**Pier 26 Upland Park Construction – Sitework, Demolition, and Concrete  
Project/Contract #C4891-B  
Addendum # 4  
December 3, 2018**

**3. Attachment A of the RFP contained in the Project Manual is hereby amended as follows and as specifically set forth in Attachment 1 herein:**

**(A) "1. C4891 –A-E Pier 26 Upland Park Construction" is amended to include the following drawing modifications:**

**(B) "4. C4981-B Sitework, Demolition, and Concrete – Specifications" is amended to include the following specification modifications:**

L-210.00

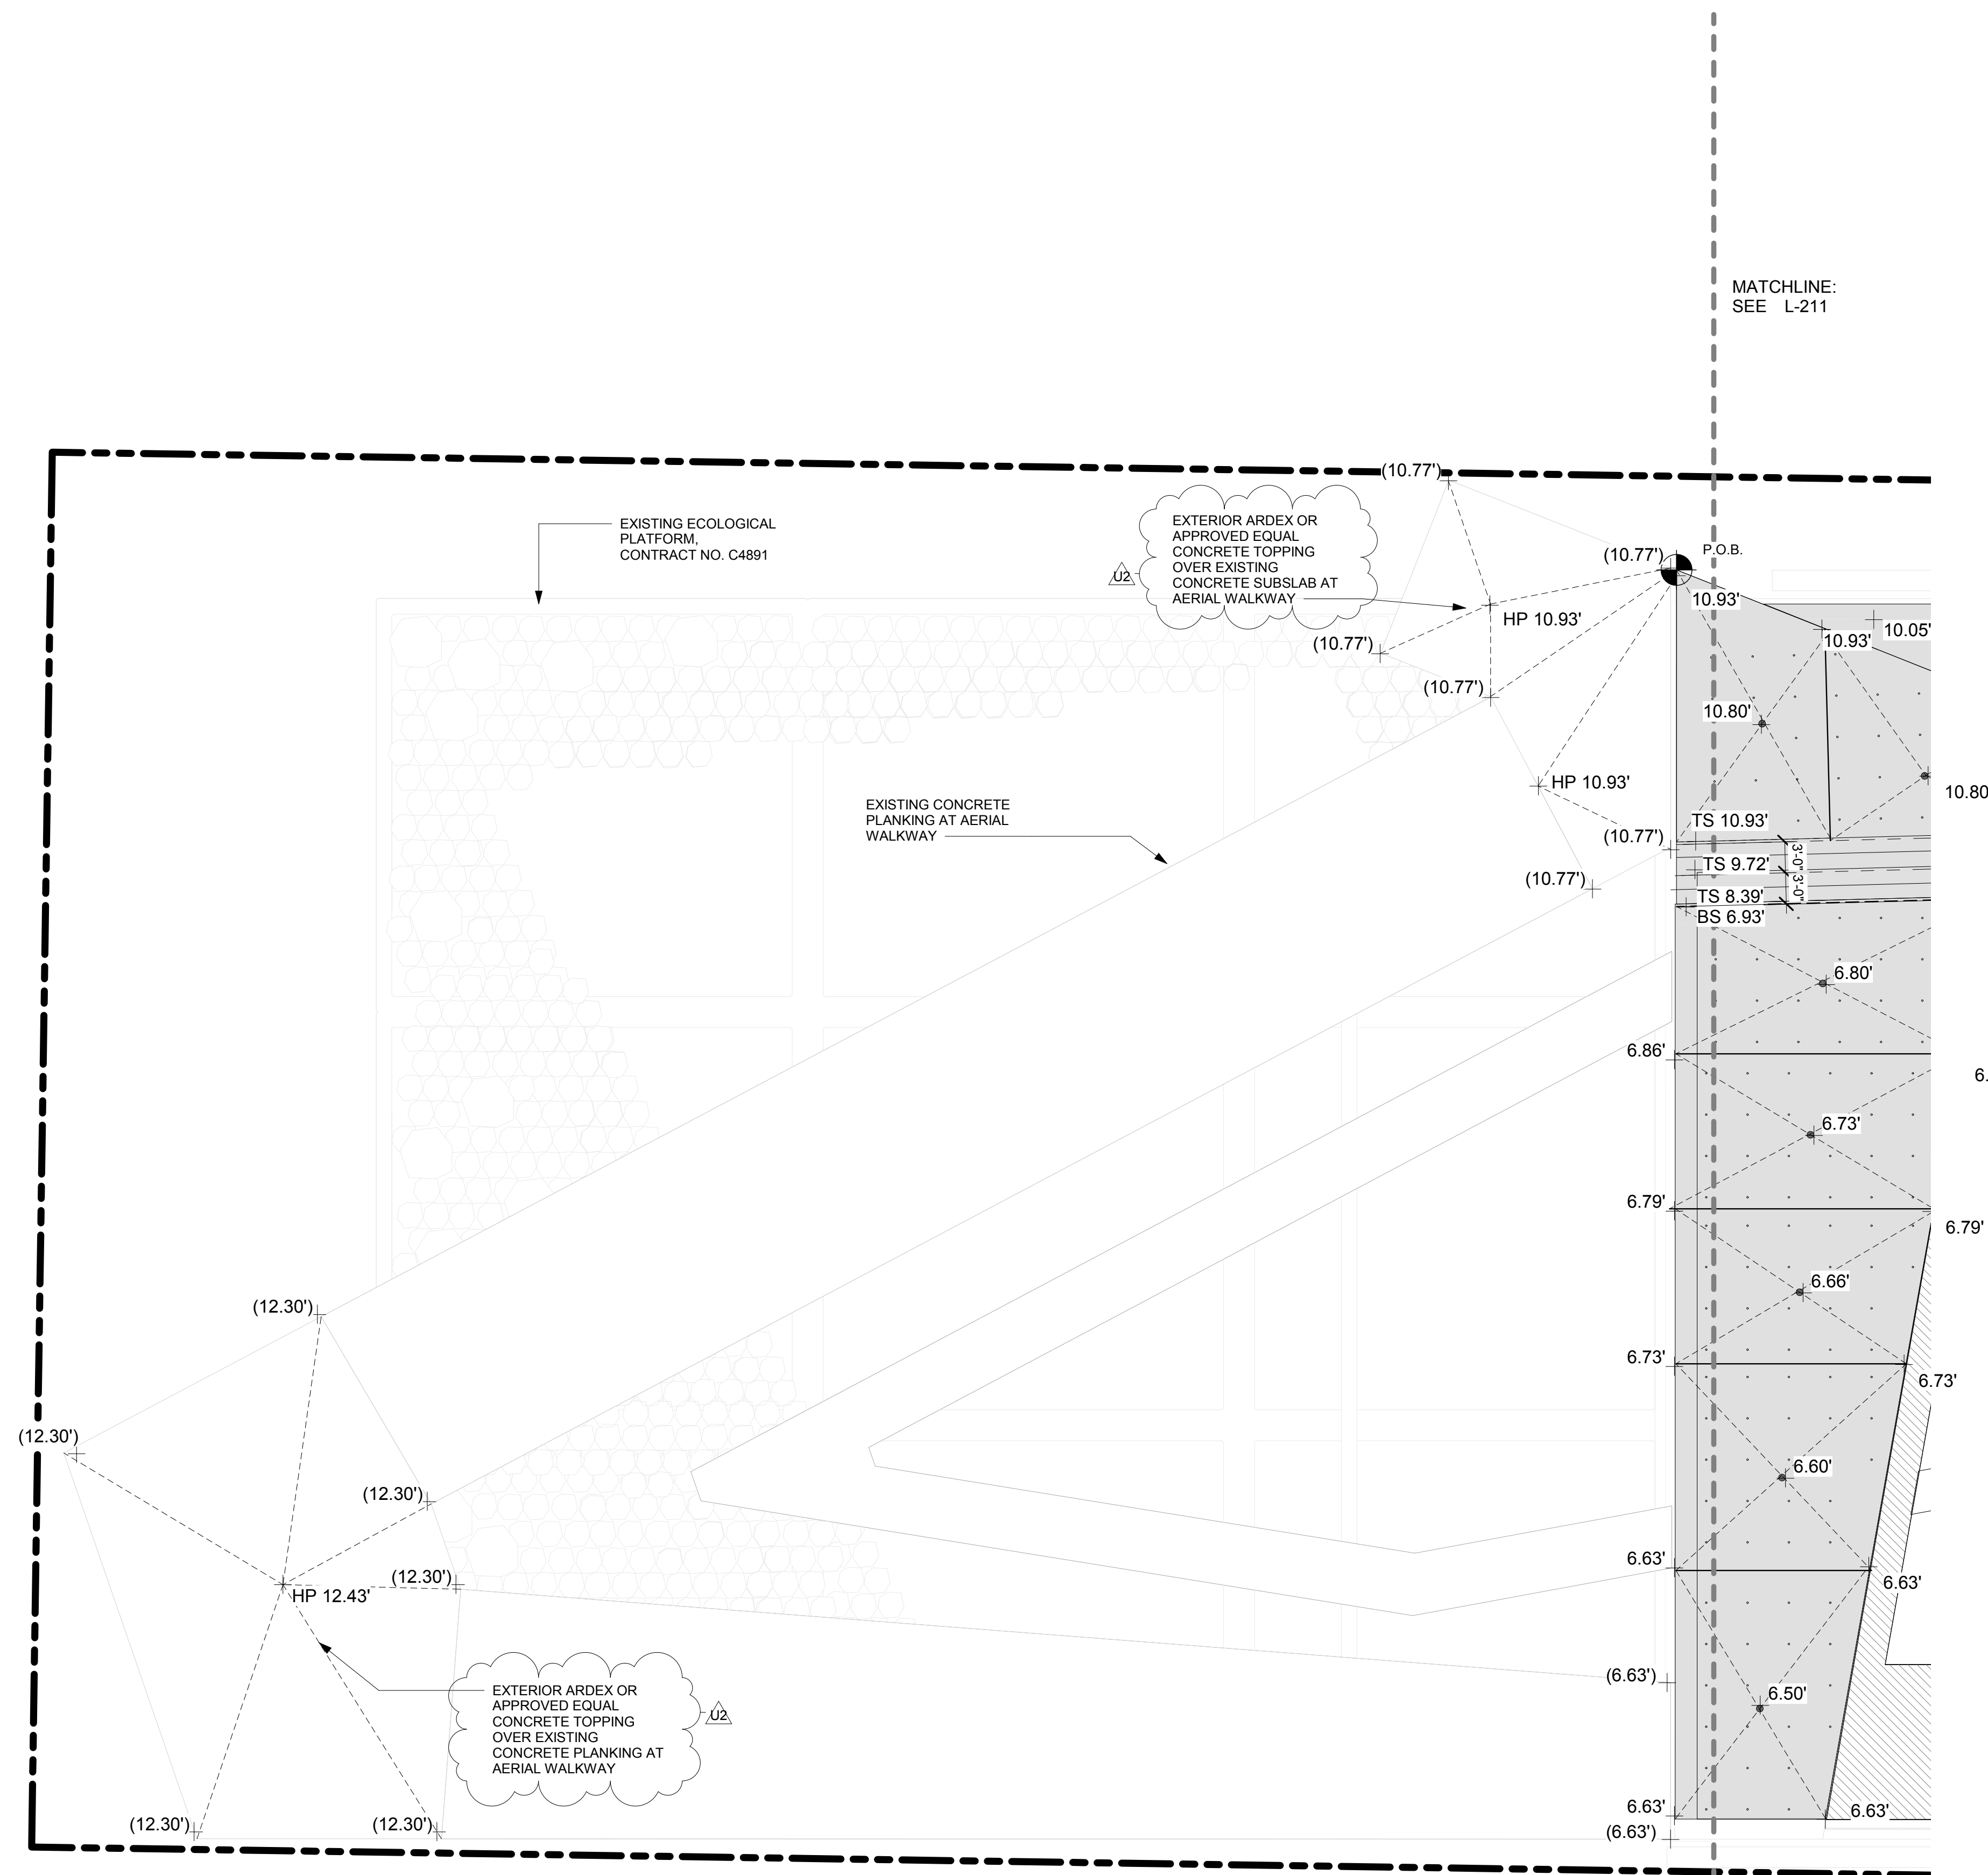
<b>Drawing</b>	<b>Update</b>
L-210-DECK SUBSLAB LAYOUT&GRADING PLAN - PIER A	Topping slab description clarified.
L-230-PAVING& DECKING PLAN- PIER A	Legend corrected to say inlaid finish, instead of sandblast inlaid finish.
L-231 - PAVING & DECKING PLAN - PIER B	Legend corrected to say inlaid finish, instead of sandblast inlaid finish.
L-232 - PAVING & DECKING PLAN - PIER C	Legend corrected to say inlaid finish, instead of sandblast inlaid finish.
L-233 - PAVING & DECKING PLAN - PIER D	Legend corrected to say inlaid finish, instead of sandblast inlaid finish.
L-234 - PAVING & DECKING PLAN - NORTH UPLAND	Legend corrected to say inlaid finish, instead of sandblast inlaid finish.
L-243 - PAVING MODULES	The unique shell inlay material has been removed.
L-400 - GRADING PLAN - PIER A	Symbol for slot drain and trench drain has increased visibility.
L-401 - GRADING PLAN - PIER B	Symbol for slot drain and trench drain has increased visibility.

GRADING PLAN - PIER C

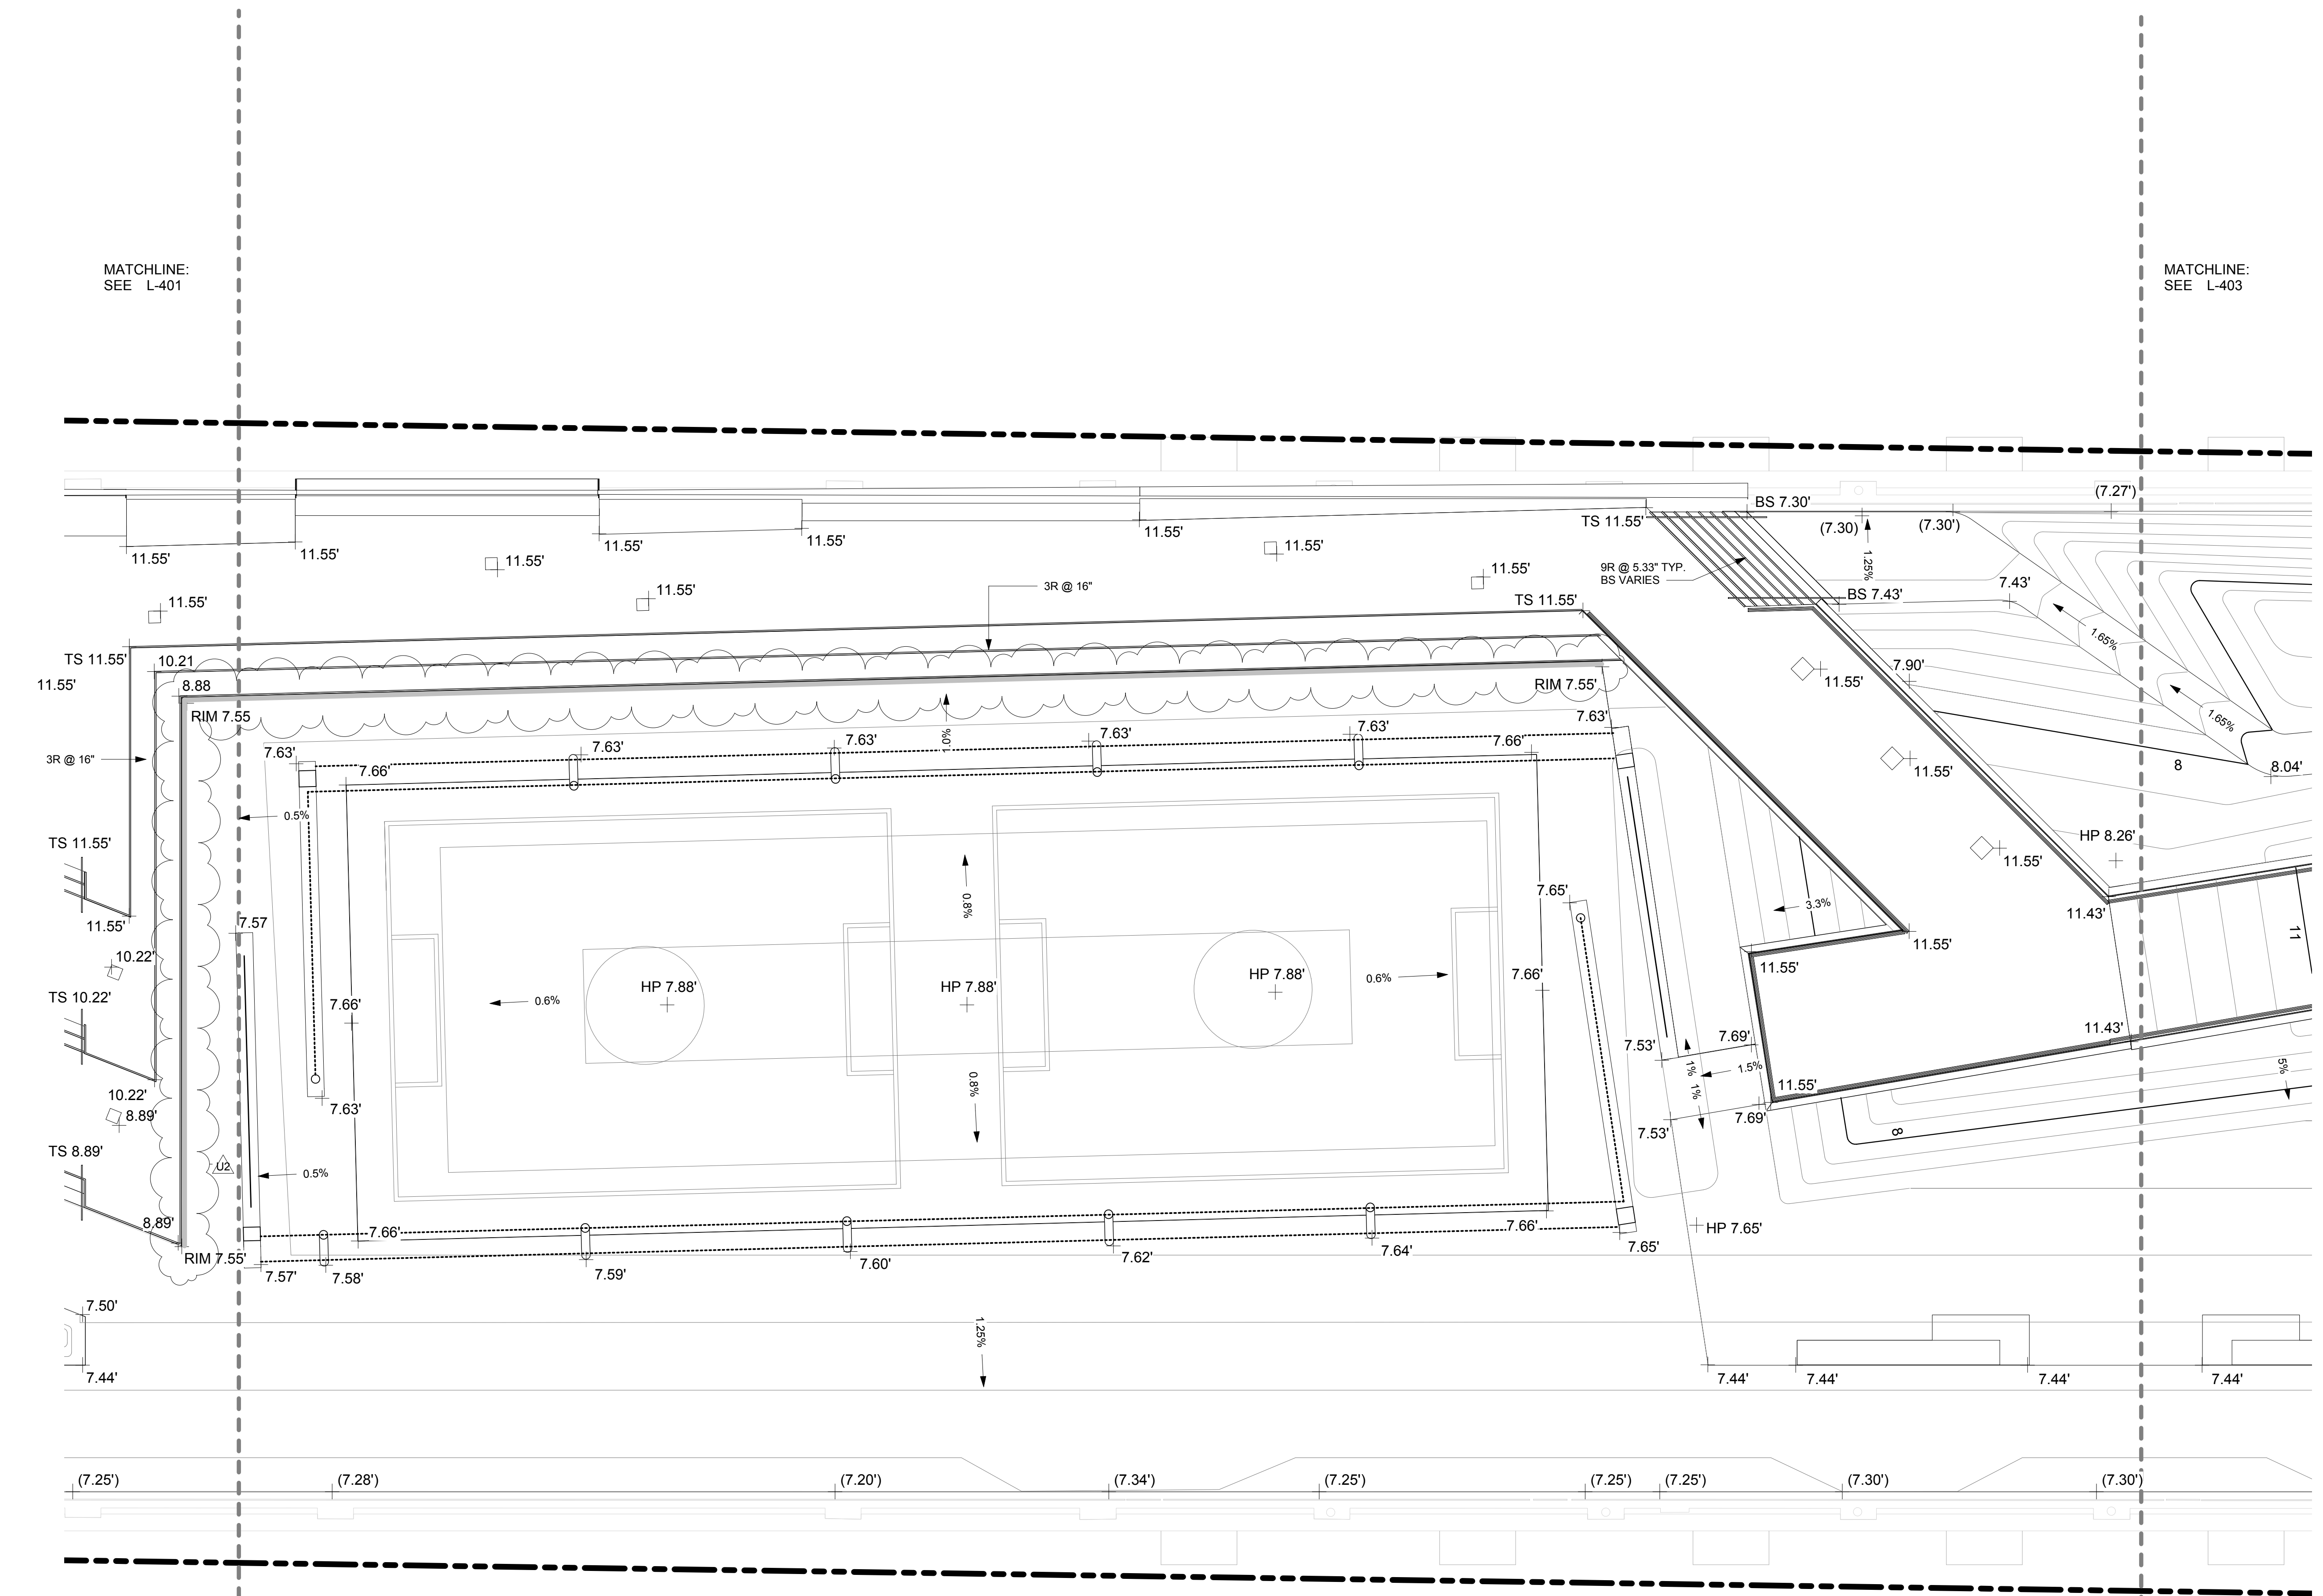
L-402 - GRADING PLAN - PIER C	Symbol for slot drain and trench drain has increased visibility.
L-403 - GRADING PLAN - PIER D	Symbol for slot drain and trench drain has increased visibility.
L-404 - GRADING PLAN - NORTH UPLAND	Symbol for slot drain and trench drain has increased visibility.
S-301 - FRAMING PLAN - PIER B	Walkway south of seating terrace no longer called out as 8" concrete seating step.
S-302 - FRAMING PLAN - PIER C	The thickness of the concrete is correctly labeled to show the 8" depth only at the 15' wide southern, as in the materials plans.
E-301 - ELECTRICAL PLAN - PIER B	Location of Q-vault shown.
E-302-ELECTRICAL PLAN - PIER C	Electrical clarification to sport pole.
E-308 - WOOD AND STEEL SHED ELECTRICAL DETAILS.pdf	New sheet showing clarifications of electrical work at the sheds.
P-303 - SANITARY PIPING PLAN - PIER D	Cross section of piping added.
P-312 - SANITARY PIPING PLAN - PIER C	Clarification to boat service utilities.
